Seventy-second session Geneva, 20–24 February 2012 Item 3(b) of the provisional agenda Regulation Nos. 13 and 13-H (Braking) – Trailer braking

Proposal for Supplement 10 to the 11 series of amendments to Regulation No. 13 (Heavy vehicle braking)

Submitted by the expert from Denmark, coordinated and supported by the International Road Transport Union, International Commission of Technical Affairs (IRU CIT) and the Nordic Road Association, Vehicles and Transport Committee (NVF). *

Diagram 1

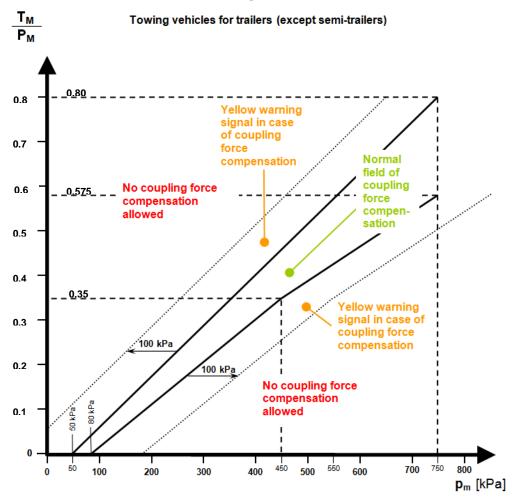
"5.2.1.28.5. The coupling force control system shall tend to minimise the coupling force. Maximum allowed compensation by the coupling force control system is 100 kPa below the lower limit of the compatibility band and 100 kPa above the upper limit of the compatibility band as specified in Annex 10. If this compensation causes the operating point to lie outside the compatibility band as specified in Annex 10 for the motor vehicle the yellow warning signal specified in paragraph 5.2.1.29.2. shall be activated. After recoupling, no compensation is allowed before the coupling force control system has registered a difference between the braking rates of the vehicles in the combination. "

Diagrams 1 and 2, amend to read:

Annex 10, diagrams 2, 3 and 4A, amend to read:

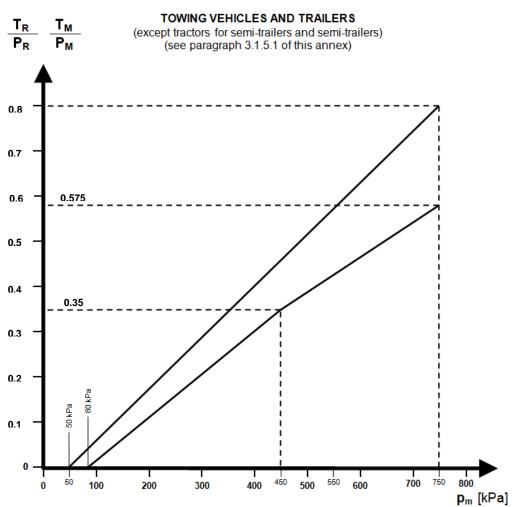
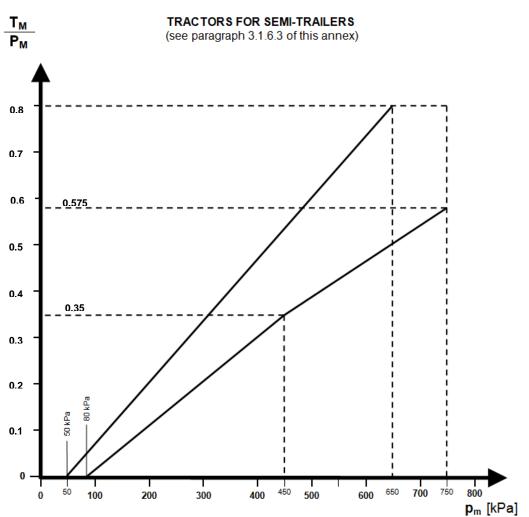
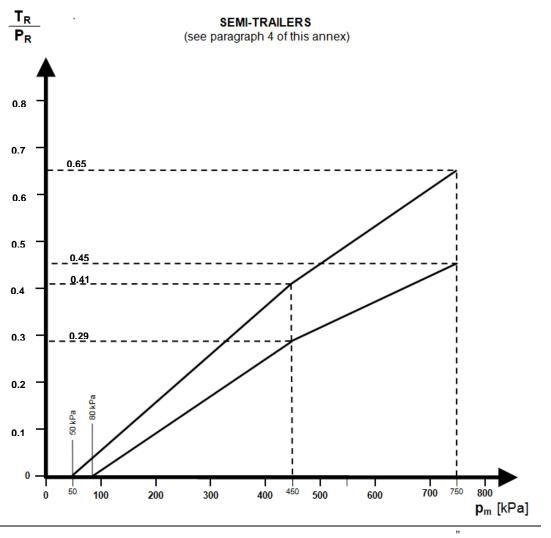
"1.3.1. At the time of type approval it shall be checked that the development of braking on an axle of each independent axle group 2/ shall be within the following pressure ranges:

At least one axle shall comence to develop a braking force when the pressure at the coupling head is within the pressure range 20 to 100 kPa.

At least one axle of every other axle group shall commence to develop a braking pressure at the coupling head is at a pressure ≤ 120 kPa.

All axels At least one axle shall commence to develop a braking force when the pressure at the coupling head is within the pressure range 20 to 100 50 to 80 kPa."

Annex 10, diagram 2, 3 and 4A (compatibility):

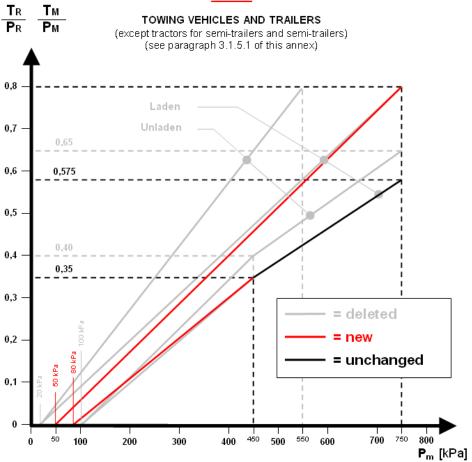
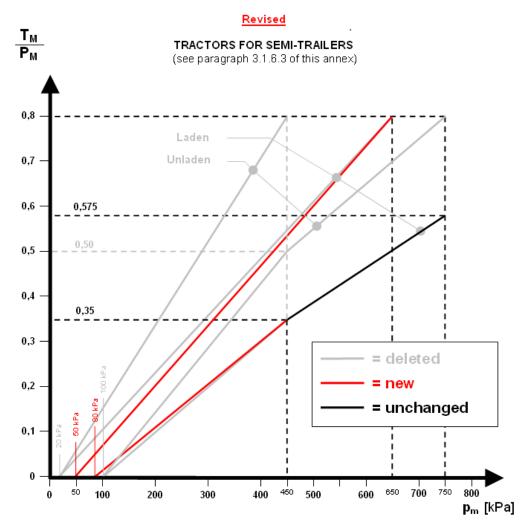
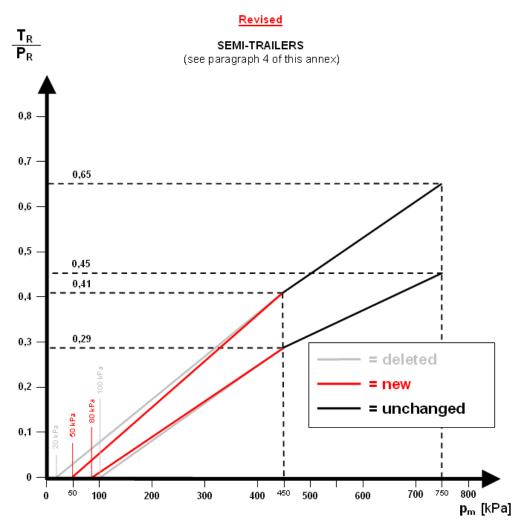
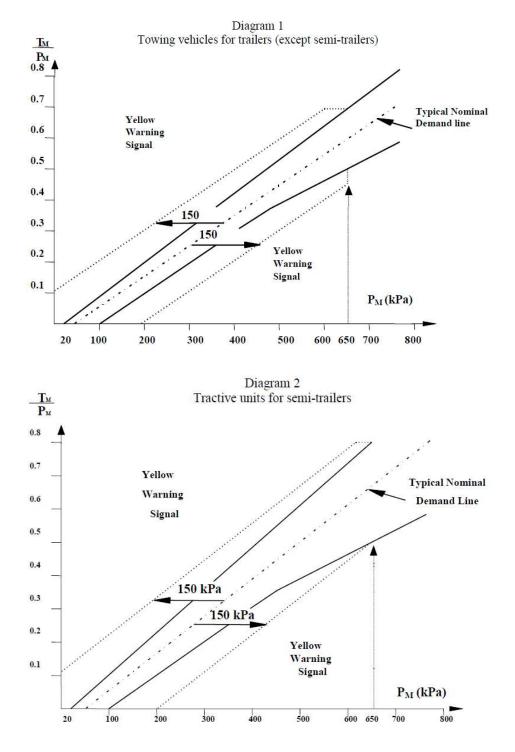
- (d) The ISO 20918 International Standard "Road vehicles Braking threshold pressures for heavy commercial vehicle combinations with fully pneumatic braking systems -Test with roller brake tester" describes a method to evaluate the braking threshold of heavy commercial vehicle combinations with pneumatic braking systems by means of a roller brake tester. This International Standard describes procedures for workshops and garages and provides a recommended pressure range of the system threshold pressure for motor vehicles and trailers, and a recommended practice for determining the system threshold pressure. The standard says that optimization and low ad hesion utilization requires good braking balance between axles in the pressure range up to 200 kPa. This improvement in balance is achieved by minimizing the variation in pressure when all brakes start to develop a braking force and recommends an interval of 50-80 kPa.

- (e) Likewise inspiration has been found in the former Swedish voluntary <u>XTB (Extra Tested Brakes) maintenance prescription</u>. The XTB maintenance prescription recommended a brake activation pressure of 50 to 80 kPa for each individual wheel brake. A similar demand were planned to be introduced in Swedish national demands at Periodical Technical Inspection (PTI), but it was not implemented due to the less stringent EU/ECE demands: The UN Regulation No. 13 allows for a brake activation pressure spread between 20 and 100 kPa for each vehicle in the combination, which is a too wide tolerance by today's standards.

- (e) the ISO 20918 standard limits the starting pressure span to 50 kPa 80 kPa;
- (f) Swedish experiences has shown that the ISO 20918 pressure span of 50 kPa 80 kPa can be fulfilled even with conventional non-EBS vehicles (<u>Better brakes on heavy vehicles, 2005</u>);

The following diagrams show the difference between the existing diagrams and the new proposed diagrams:
